Lych Gate Cottage, Cauldon
Proposed Elevations, Window & Door Details & Rainwater Goods
shown without cotoneaster & replacement door canopy at front elevation - for clarity

Document Scope: LBC

Section Profiles 1:5

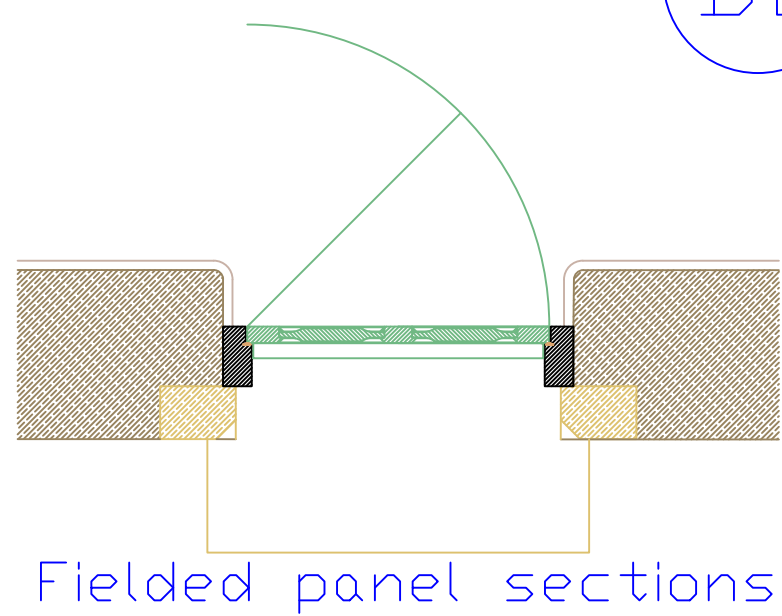
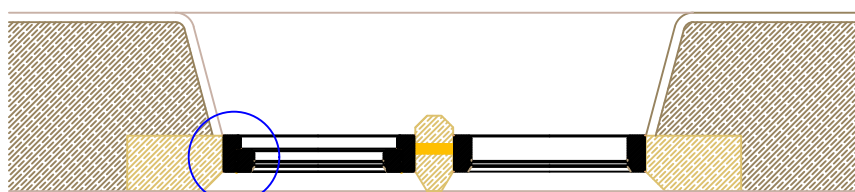
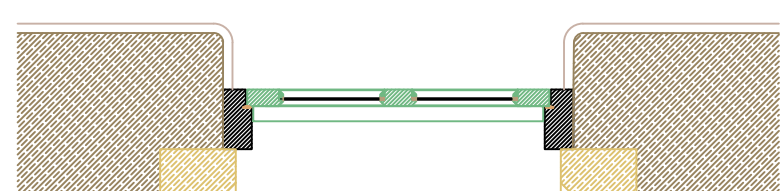
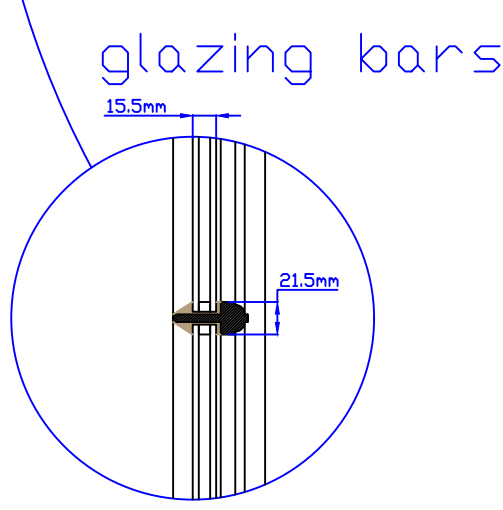
- Rev 0 to Rev 1:
- 1). True glazing bars indicated (not planted glazing bars)
 - 2). 4+7.5+4 Slim-line Glazing Units indicated (not 4+12+4)
 - 3). Glazing fixed with external putty bead (not timber beading)
